Value Engineering Study

Final Report

VE Number: 202303

I-75 Widening, MP 20.2 to MP 28.851 Laurel & Whitley Counties

53

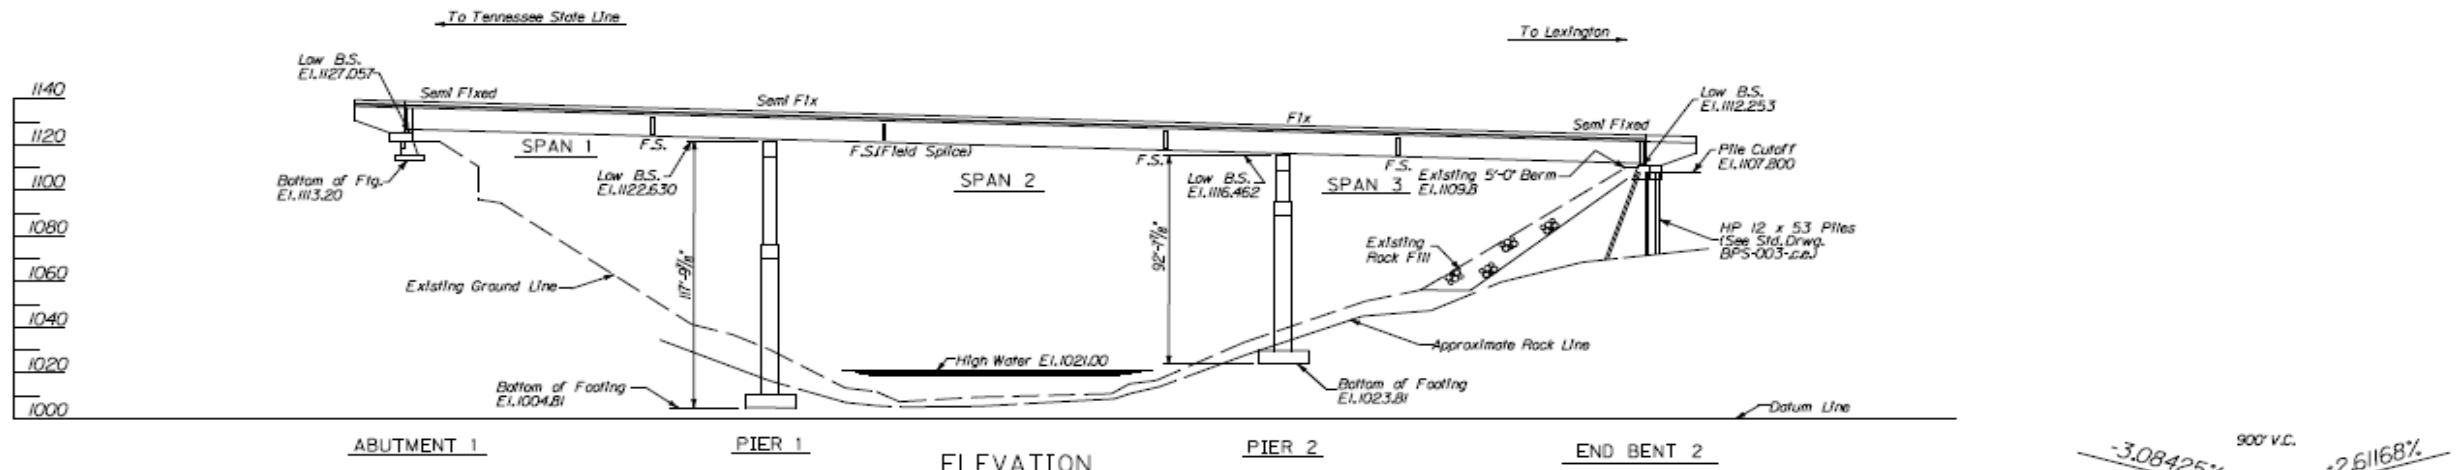
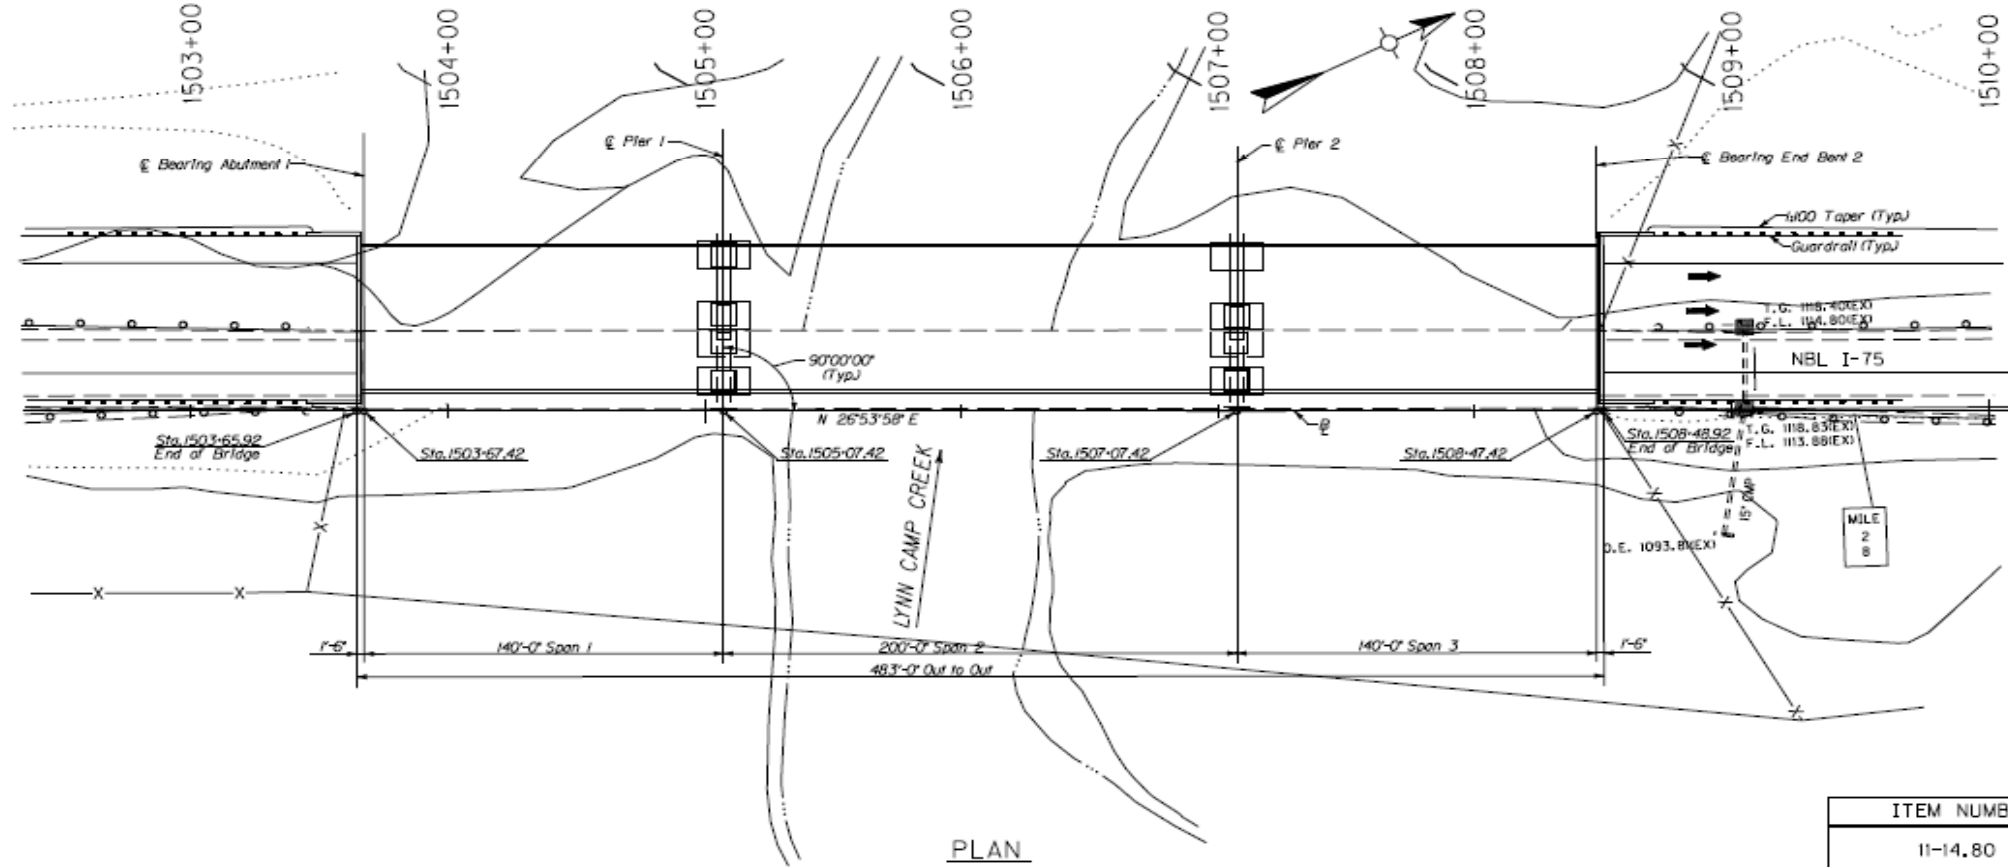
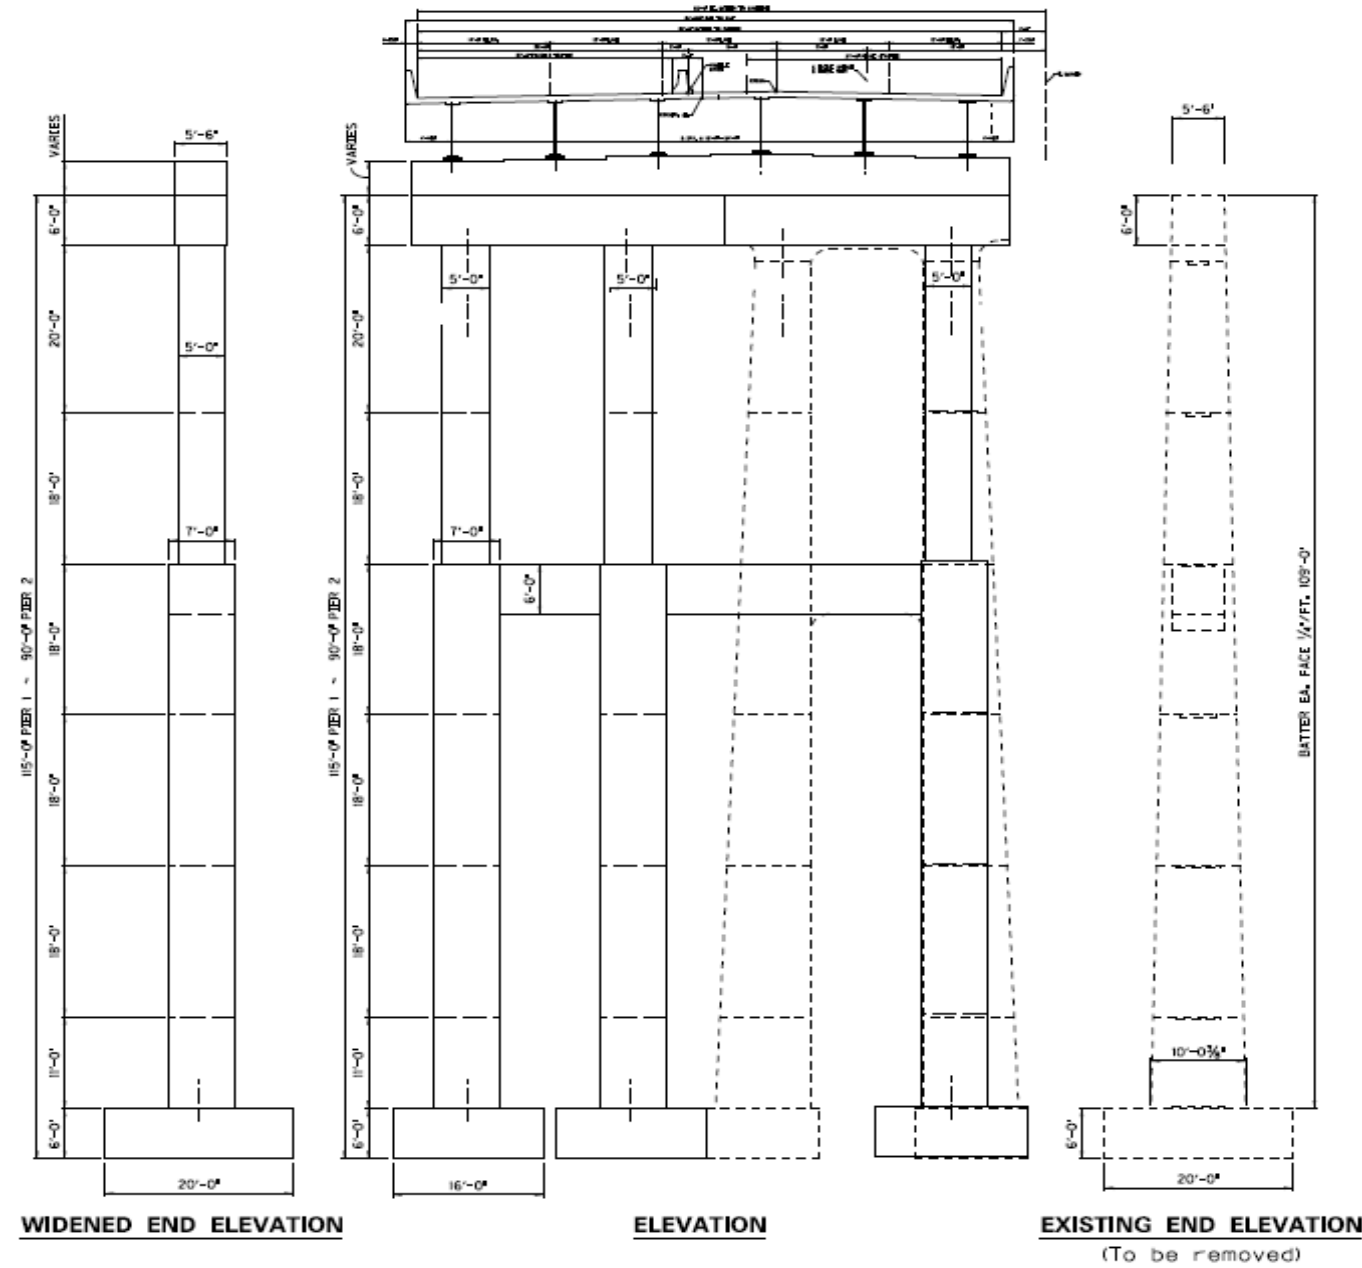
TITLE	Build a single span steel girder for Lynn Camp Bridge construction		
VALUE PROPOSAL SYNOPSIS:			
The option uses a single span Plate Girder span to cross Lynn Camp Creek. The option does not use tall piers like the continuous plate girder bridge.			
 Reliability	Maintained	 Functionality	Maintained
 O&M	Maintained	 Schedule Impact	Improved
			\$ Initial Cost Avoidance (Add)
			(\$18,023,000)
BASELINE CONCEPT:			
A new bridge for NB and SB over Lynn Camp Creek is desired by KYTC. The basic configuration of a new bridge would be a continuous three span (160-200-160) steel Plate Girder bridge with widen new piers in the same location as the existing piers.			
VALUE PROPOSAL DESCRIPTION:			
Construction of tall piers (90'-100') can be avoided by using a single span plate girder bridge. The natural slope up from Lynn Camp Creek will meet the bottom of the proposed bottom of the girders such that shallow abutments or End Bents can be utilized.

TITLE	Build a single span steel girder for Lynn Camp Bridge construction
DISCUSSION & JUSTIFICATION:	
<p>The information provided by the project team led the value team to conclude that the final design of the Lynn Camp Creek bridge will be a continuous three-span steel plate girder bridge. The baseline structure will replace the piers in their current location. However, construction of the new piers pose a constructability concern.</p> <p>The value team proposes to place a single span plate girder bridge. This would minimize the need for equipment to be down near the creek. Shallow abutments or end bents can be utilized and constructed from the top behind barrier wall. Access walks can be constructed for personnel with materials such as concrete being pumped from the top. Beams can be launched using a gantry instead of requiring large cranes in the creek area.</p> <p>Access to the creek will still be needed for removal of the existing pier caps, but the access route and crossing will be minimal compared to that needed for the pier construction.</p> <p>By eliminating the pier construction, the phasing duration for the bridge construction is greatly reduced. It is assumed that the Lynn Camp Creek structure will be on the critical path of the project. Reduction in the duration of this structure will lead to an overall reduction in the project schedule.</p>
